Source: Prestolite Electric Ltd - Greenford, London, UK
Date: October 16, 2017
Bulletin No: TSB4032_66021507
Models: AC5RS & AC5RSM
Subject: Alternator supersession

AC5RS / AC5RSM Supersession

66021507 Wiring

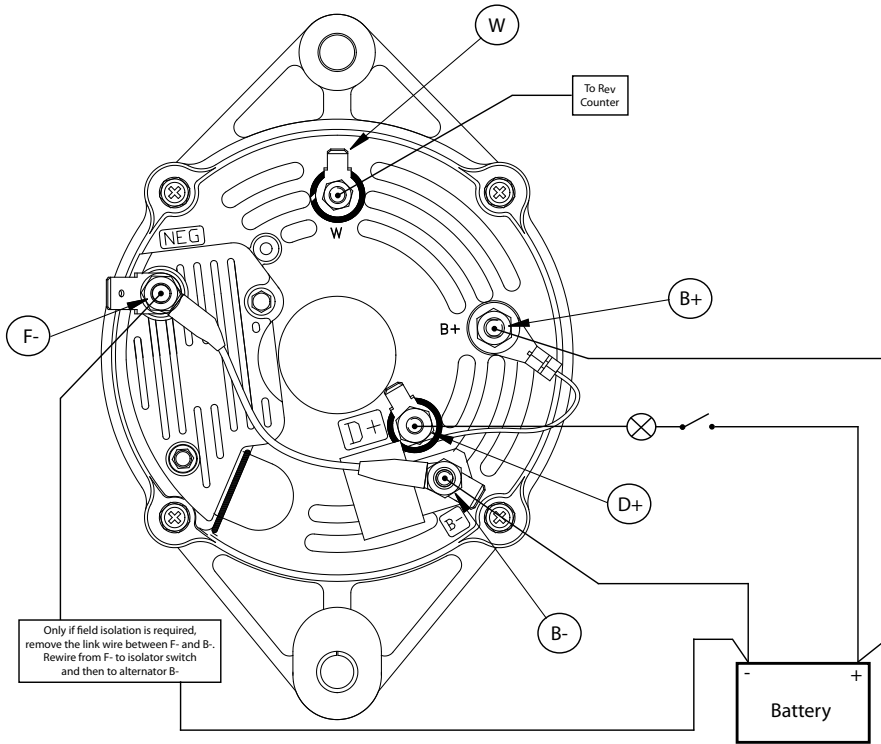
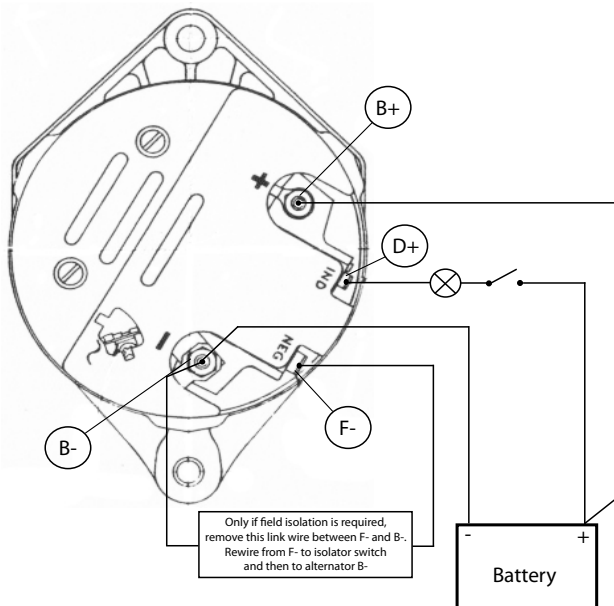
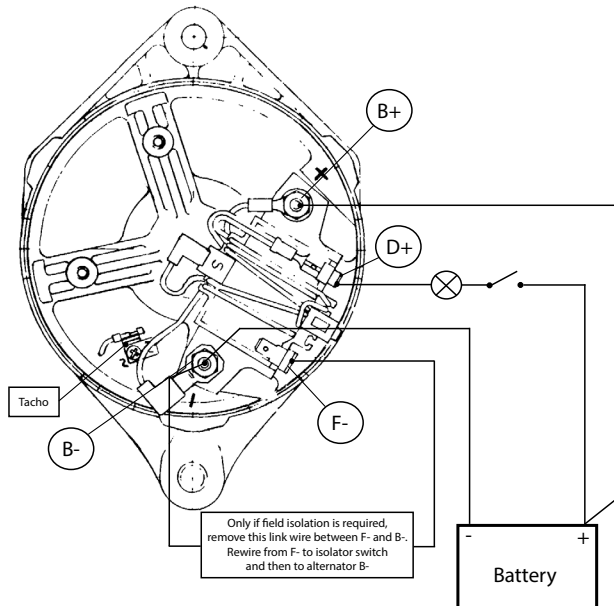
All the mechanical fitting are identical. The new alternator also has all the same electrical connection, but in slightly different positions. See page 2 for wiring diagrams.

The marine version (AC5RSM) could also be replaced by the 66021507. The mechanical interface is the same (i.e. mountings, and shaft), however the new alternator does not have a marine finish and the wiring (termination) on the boat would need to be adapted to suit new style alternator.

The standard version (AC5RS) has been superseded by part no. 66021507, which is an AS128eHD type alternator.
